Schofields Public School

*State Significant
Development
Modification
Assessment
(SSD 8740 MOD 1)*

December 2019

Figure 4 | Proposed Site Plan (Base source: Applicant's Modification Application 2019)

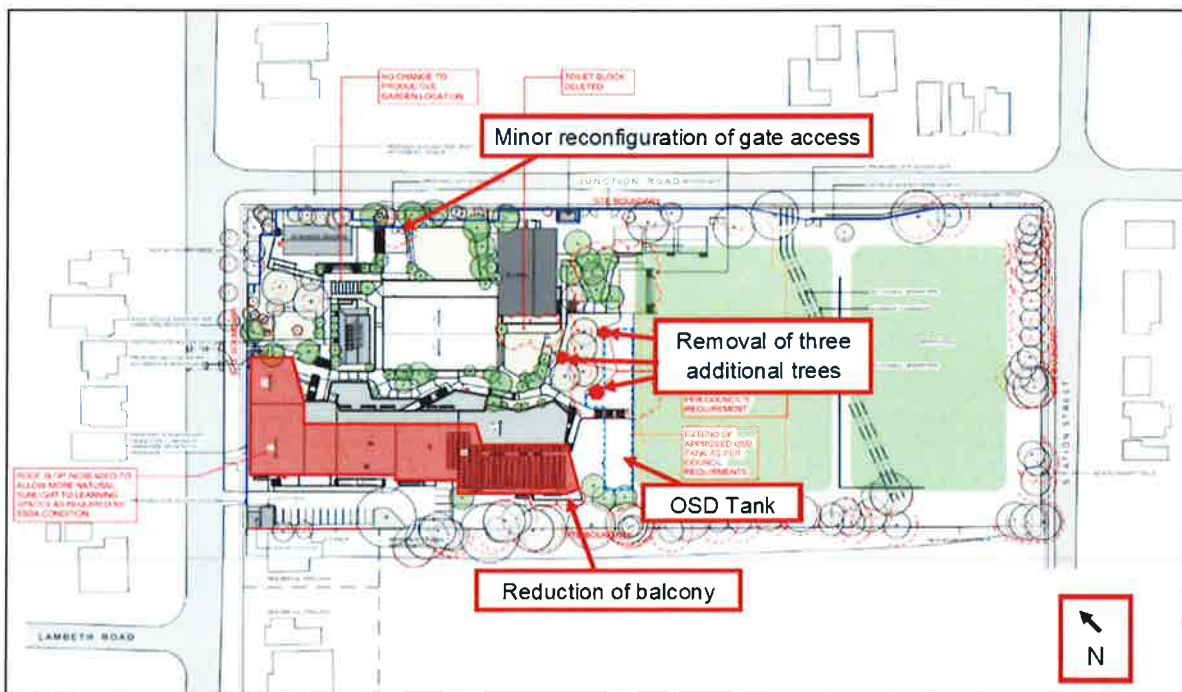
The proposed change to the eastern access gate involves a minor relocation so that the gate is located within a proposed recessed section of fence line that would be set off from the boundary of the site. The Department considers that this constitutes a minor amendment to the proposed fencing

layout and would result in a more inviting entrance to the site from Junction Road. The change would not result in any additional environmental impacts.

Figure 6 | Proposed Ground Floor Plan (Base source: Applicant's Modification Application 2019)

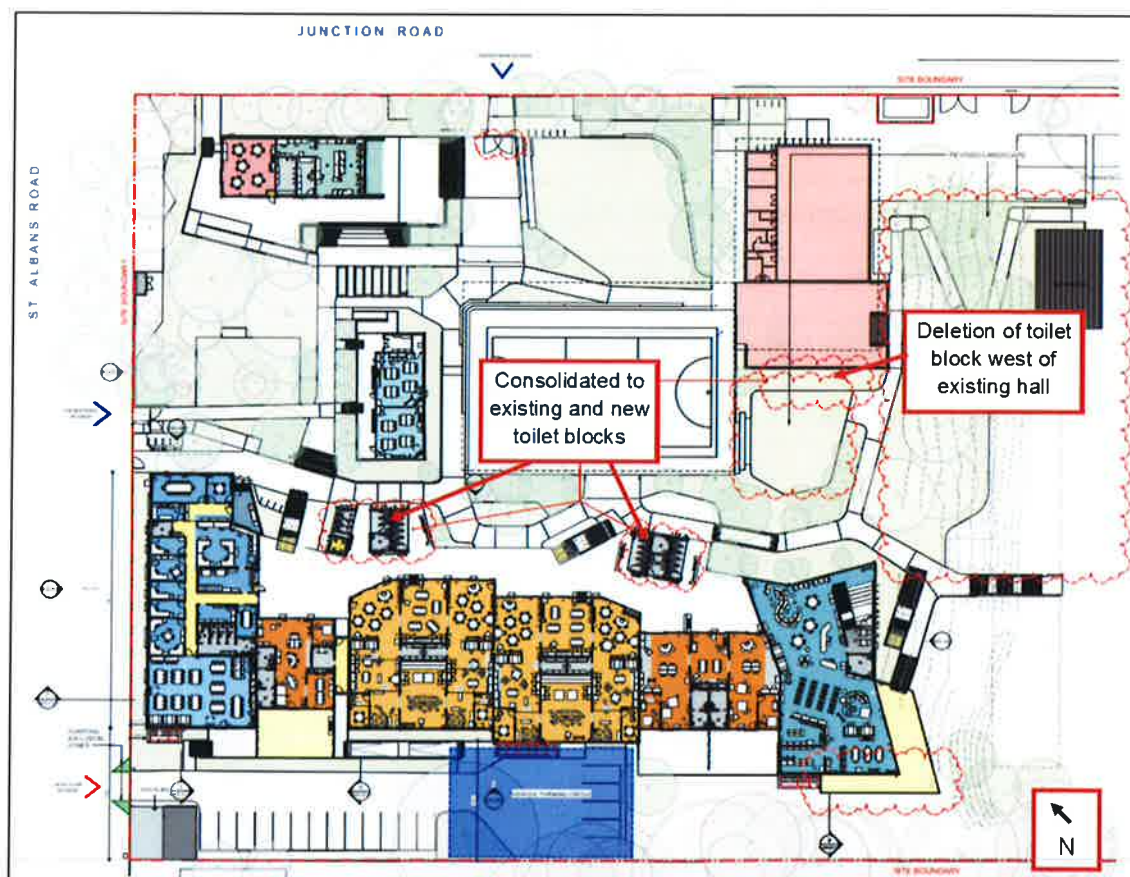
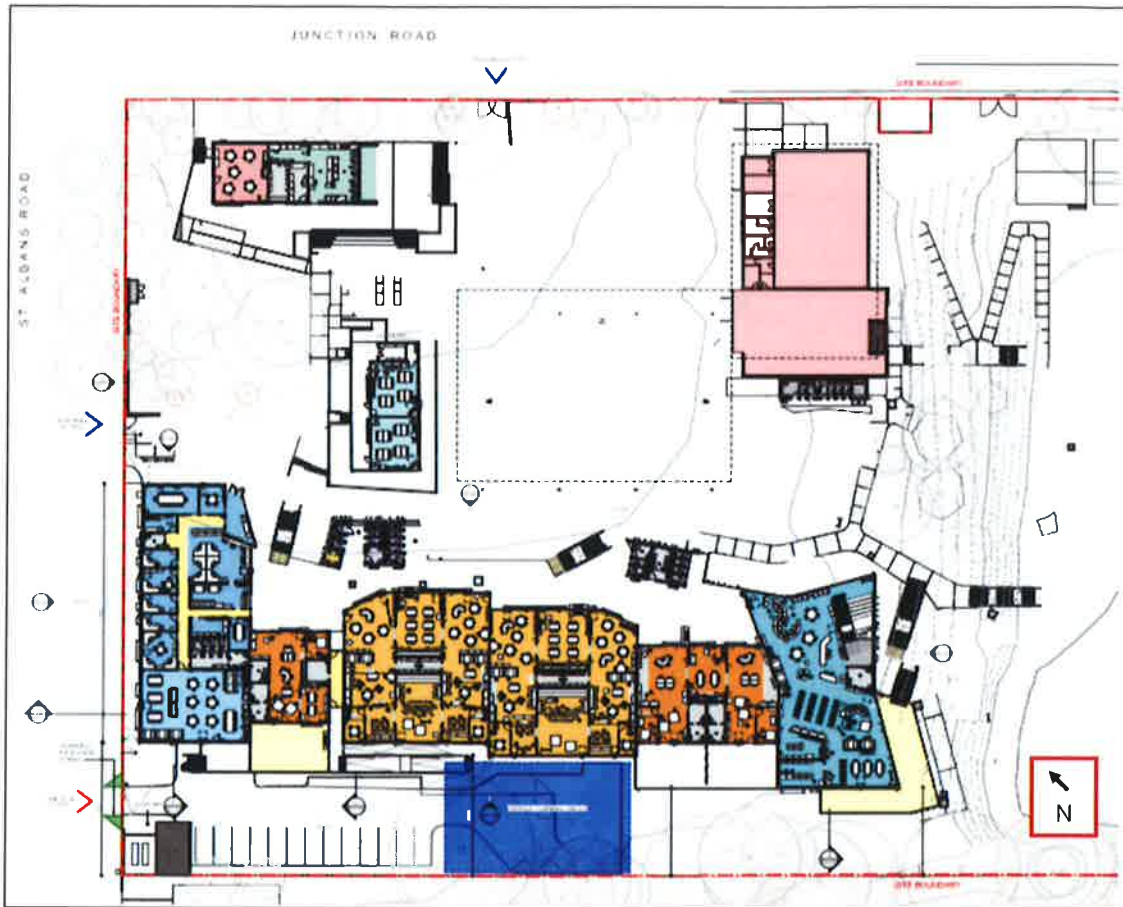
The changes to the ground floor toilets include the deletion of a toilet block to the west of the existing hall and consolidation of these toilets into the three remaining ground floor toilet blocks. The changes to the first floor toilets include a minor reconfiguration and increase in the number of toilets in the two toilet blocks proposed on the first floor of the proposed school building.

The Department considers that the changes to the toilet facilities would be internal to the site, would barely be visible from outside of the site and would not therefore result in new environmental impacts.

Figure 8 | Proposed First Floor Plan (Base source: Applicant's Modification Application 2019)

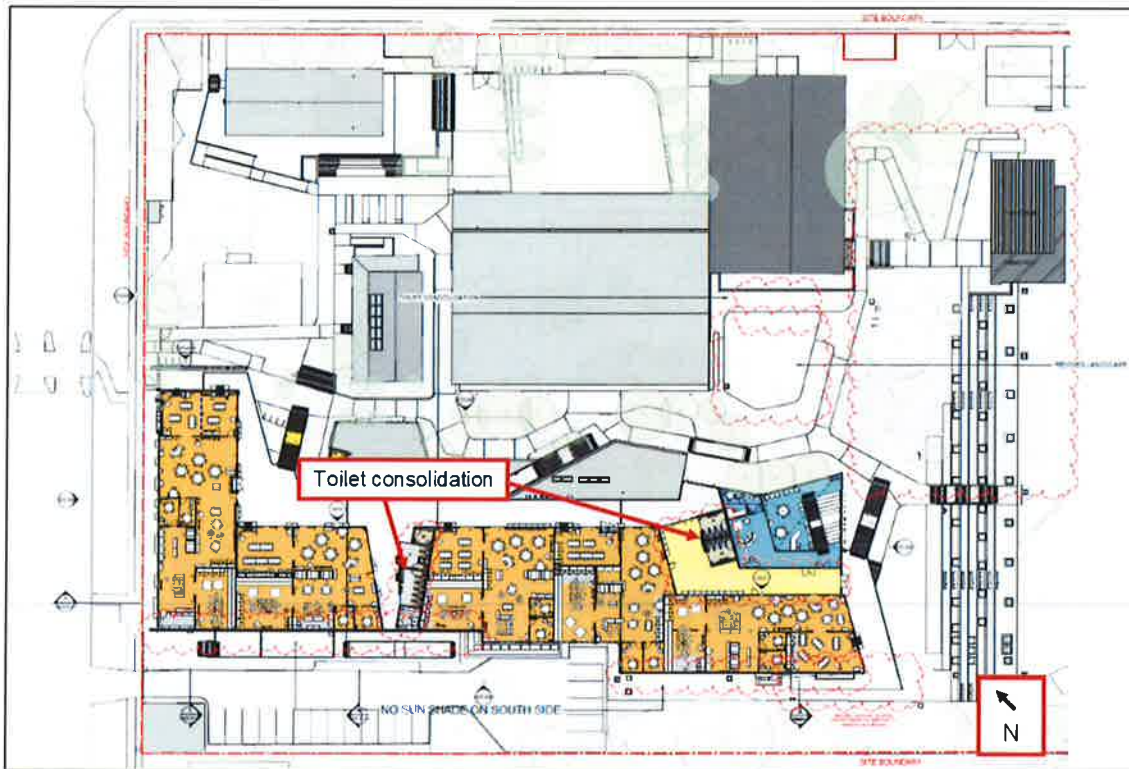
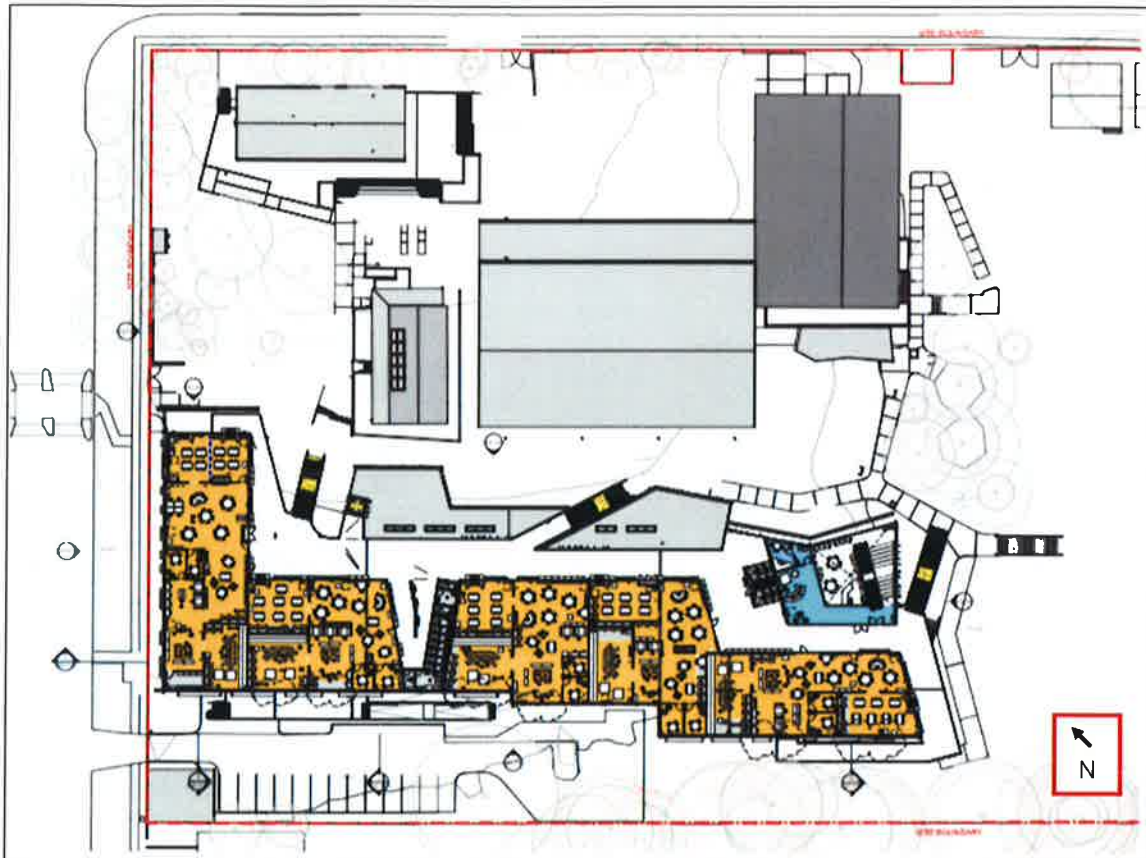
The proposed change to the balcony on the southern elevation of the proposed new school building involves a reduction in the length and depth of the balcony. The change would therefore reduce the bulk of the structure and would further reduce the potential for overlooking or overshadowing of adjoining residential and Council land. On this basis, the Department considers that the proposal would not result in new environmental impacts above those previously considered.

Figure 12 | Proposed Landscape Plan (Base source: Applicant's Modification Application 2019)

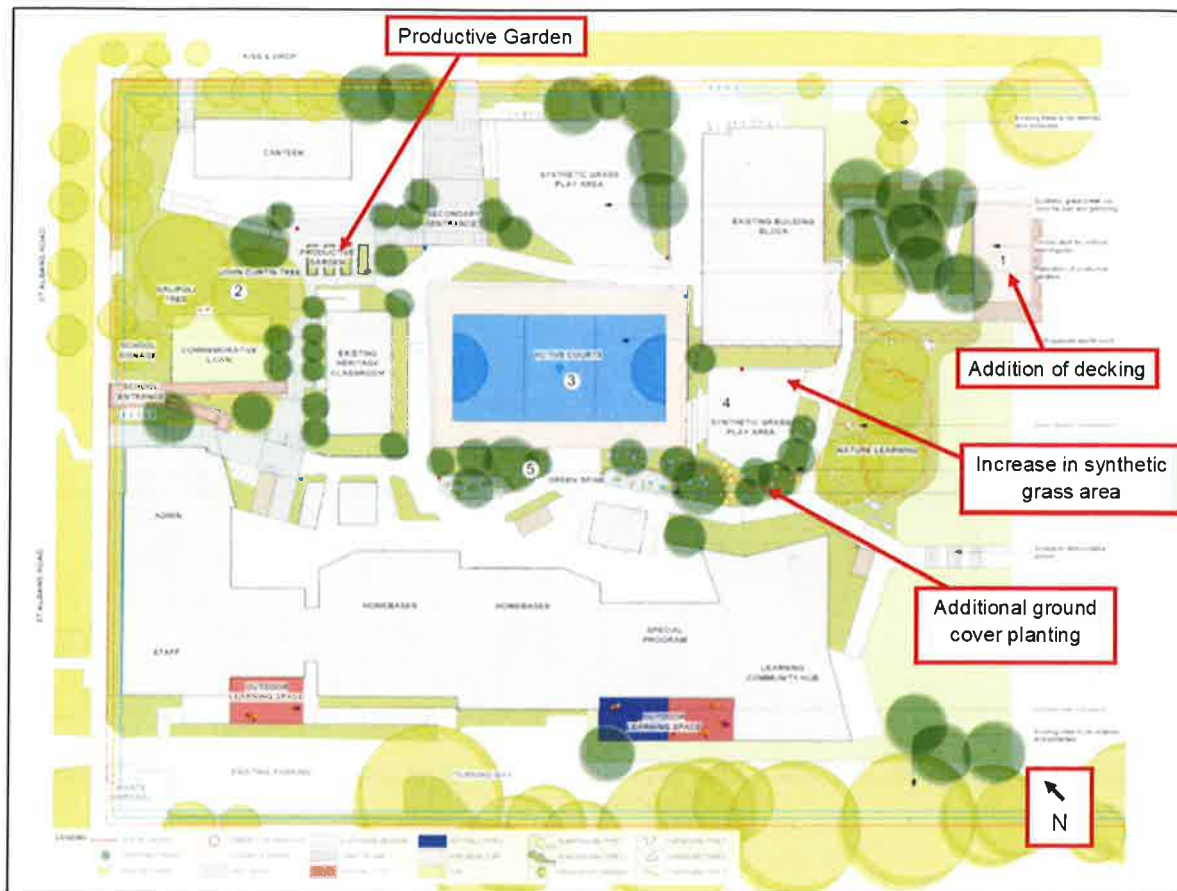
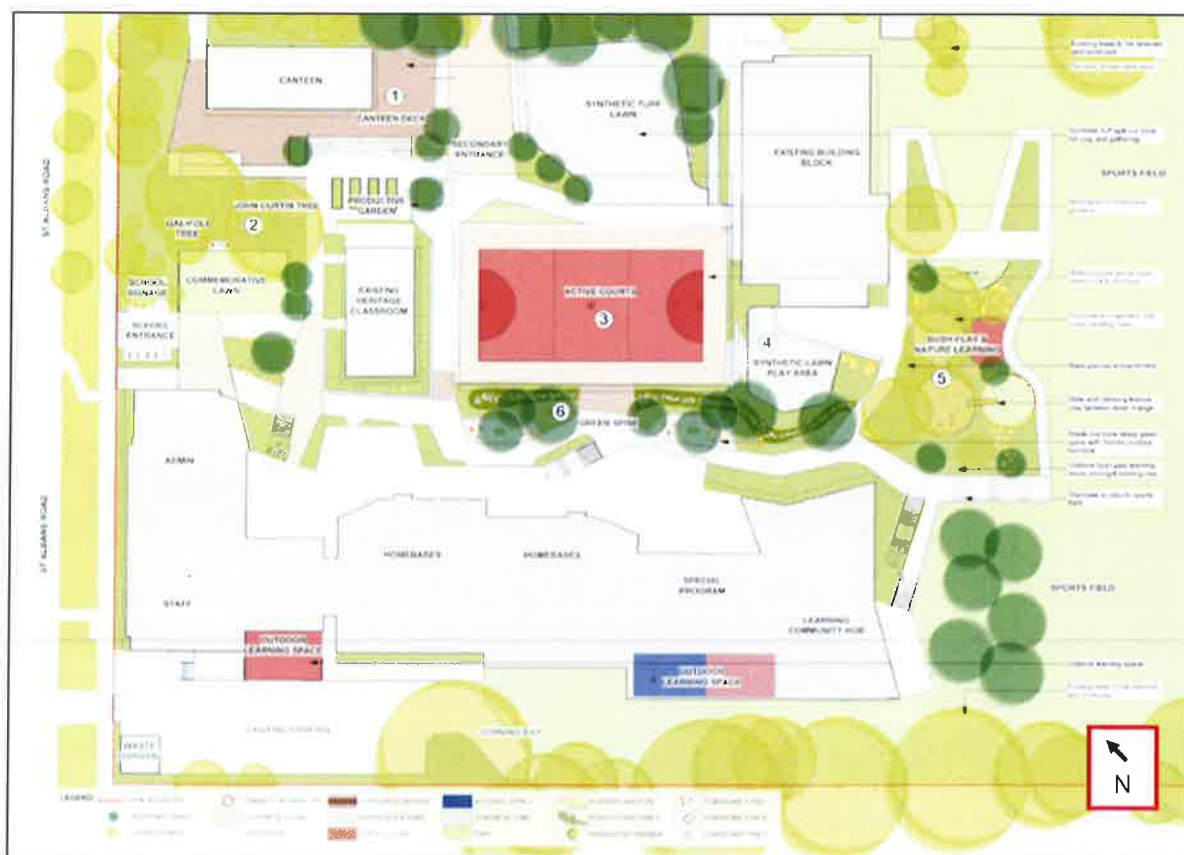
The other proposed changes to landscaping are considered to be minor in nature, would provide improved amenity and play space for the school children and would not result in any additional environmental impacts.

Figure 14 | Proposed OSD tank on the approved plan (Base source: Applicant's Modification Application 2019)

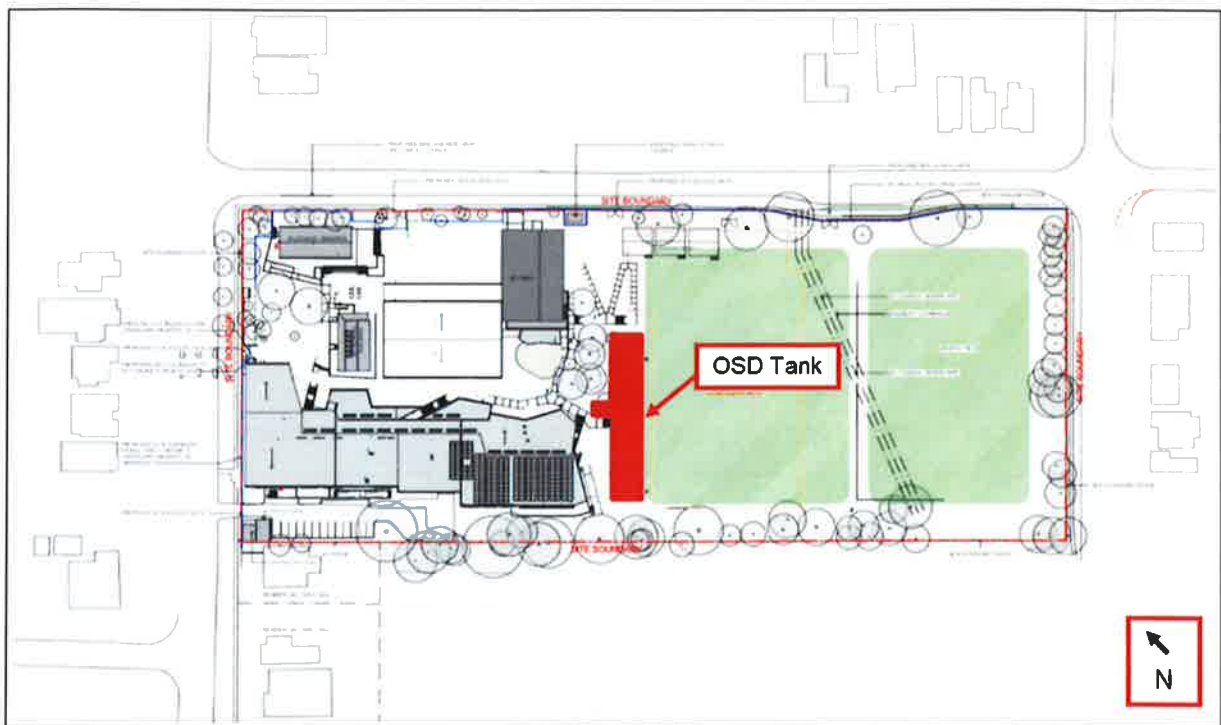
The proposal includes the provision of an OSD tank to retain water in heavy rainfall events and allow controlled discharge from the site. The approved plans locate the proposed OSD tank within the centre of the site between the existing playing fields and the built-up section of the school.

Condition B29 of the consent required the Applicant to design an operational stormwater management system for the site in consultation with Council. The Applicant advises that Council has since advised that it requires the provision of a larger OSD tank than originally proposed.

In order to satisfy the requirements of Council, the application seeks to incorporate a larger OSD tank on site. The OSD tank would generally be located in the same location as that originally proposed but would extend further into the western half of the site.

The Department notes that the tank would be located belowground and would not therefore be visible from within or from outside of the site. Consequently, the proposed modification would not have any visual impacts.

The Department acknowledges that the larger tank would require a larger volume of excavation on the site which could result in noise and traffic impacts. The Department however notes that the conditions of consent require the preparation and implementation of a Construction Environmental Management Plan (CEMP) and Construction Traffic and Pedestrian Management Sub-Plan (CTPMSP) to manage the construction (and excavation) activities on the site and construction vehicle movements to and from the site. The consent also requires construction activities to comply with the noise levels set out in the acoustic assessment submitted with the original application. These requirements would still apply to the modified proposal and would ensure that any impacts are minimised and are consistent with the impacts originally assessed by the Department.

Figure 15 | Proposed retention and removal of trees (Base source: Applicant's Modification Application 2019)

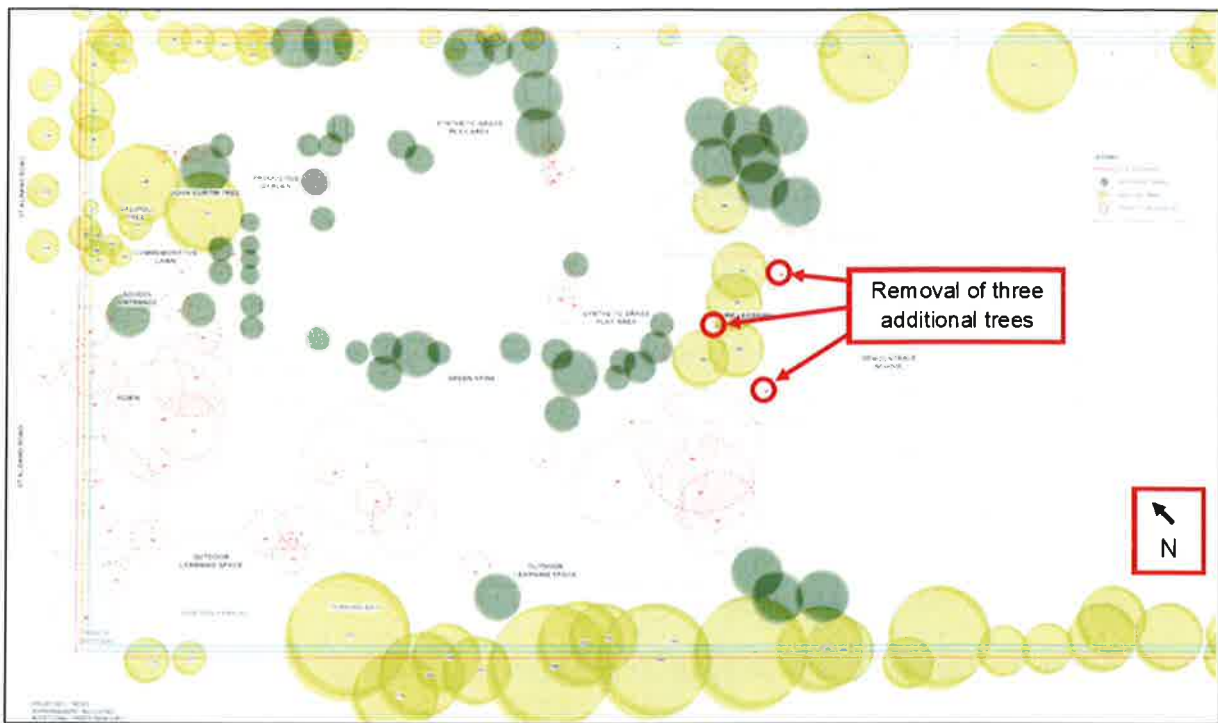
The proposed increase in the size of the OSD tank would require the removal of three additional trees (No.s 80, 87 and 93) within the centre of the site. Two of these trees form part of a locally occurring Endangered Ecological Community (EEC) and are considered 'highly significant' trees. To mitigate for their removal of the additional trees, the application proposes replacement tree planting on site at a ratio of 2:1 along with ground cover planting.

The tree additional trees to be removed are shown in **Figure 15**.

The Department considered the impacts of the tree removal proposed as part of the original development in its original assessment of the proposal, noting that the proposal involved the removal of 46 trees, retention of 76 trees and planting of 46 replacement trees on site.

The Department acknowledges that the modification would result in the removal of three additional trees and accepts that the removal of the trees is unavoidable given the need for a larger OSD tank on site and limited opportunities to relocate the tank elsewhere on site. The Department however recognises that replacement planting would be undertaken at a ratio of 2:1 which would be greater than the ratio of replanting for the other tree removal proposed on site. This would provide for maintained tree cover on the site and contribute to the landscape character of the site and amenity of the wider locality.

Overall, the Department considers that the impacts of the tree removal would be acceptable and would be appropriately mitigated through the proposed replacement planting. The Department has recommended a revision to condition D36 of the consent to require the Landscape Management Plan to include the planting of 52 trees on the site (increased from 46) to incorporate of the above proposed replacement planting.
